Mobile Intel[®] Celeron[®] Processor at 466 MHz, 433 MHz, 400 MHz, 366 MHz, 333 MHz, 300 MHz, and 266 MHz Specification Update

Release Date: September 2002

Order Number: 244444-036

H29. Thermal Sensor May Assert SMBALERT# Incorrectly

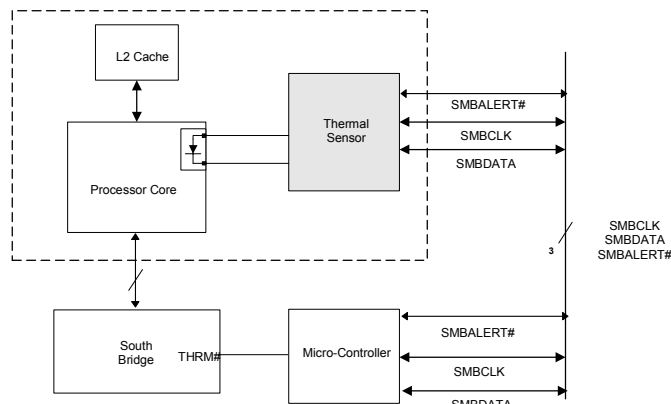
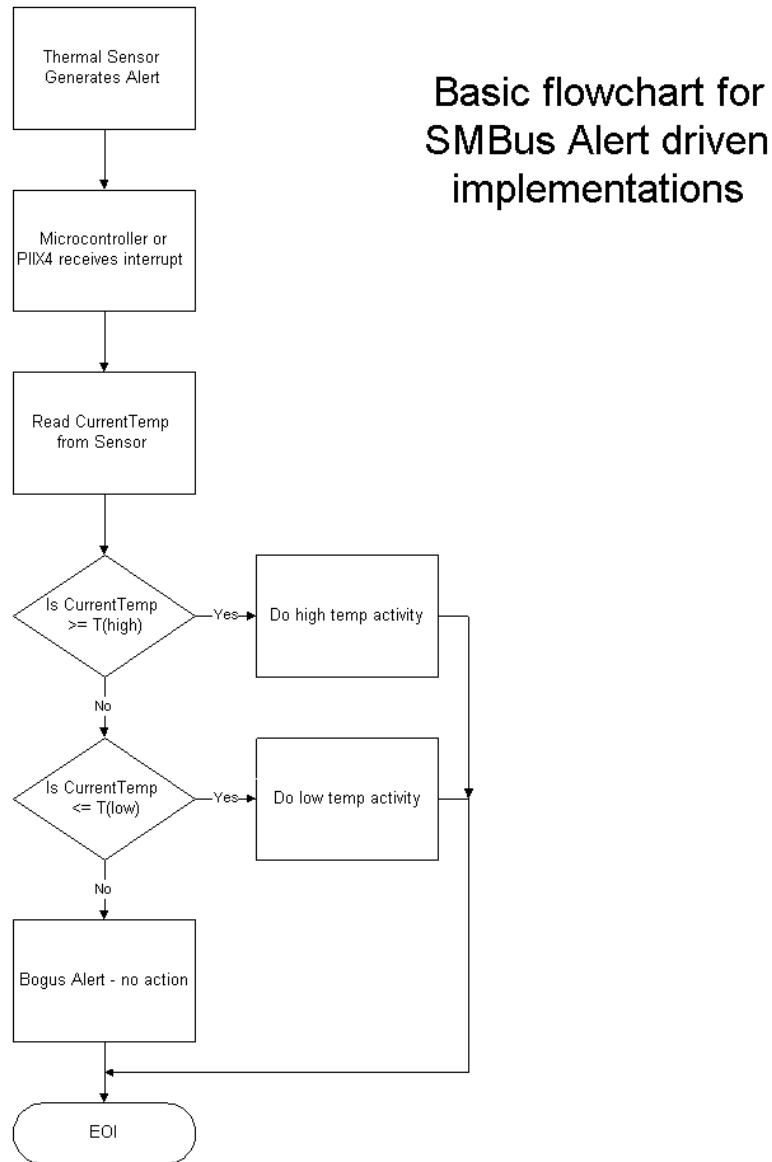
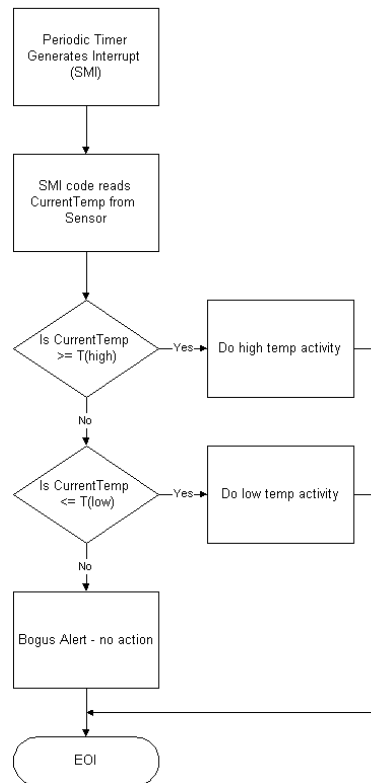
Problem: The Intel Celeron Processor Mobile Module has a thermal sensor that monitors the processor core's temperature. Please note that desktop systems could have a similar thermal device. The thermal sensor asserts SMBALERT# if the processor temperature exceeds the temperature limits set in the Alarm Threshold Registers (T_{HIGH} , T_{LOW}). It also sets the corresponding Status Register bits to identify the cause of the interrupt. Figure 1 gives one example of the how the SMBALERT# signal could be used in a system.

Implication: There is no system impact from this erratum if temperature polling is used for processor thermal management. If the SMBALERT# interrupt is employed to manage processor thermal sensing, then servicing the false interrupt may result in premature system action depending on the software and hardware implementations used. The rate of the false interrupts is less than the auto-convert rate of the thermal sensor.

Workaround: Three different (mutually exclusive) workarounds are possible:

1. Before servicing an interrupt from the thermal sensor, read and compare the processor thermal reading with the threshold limits (T_{HIGH} or T_{LOW}). Figures 2 and 3 provide basic flowcharts for the implementation of this workaround in an interrupt driven system.
2. If the firmware implemented polls the Status Register only, then before taking any action, re-read the temperature register and do a comparison with the alarm threshold limits (T_{HIGH} or T_{LOW}) to determine if the value is actually still within the temperature window.
3. Use a temperature polling scheme to monitor the processor temperature.

Figure 2. Workaround Flowchart: SMBALERT#-Driven System

Figure 3. Workaround Flowchart: SMI#-Driven System
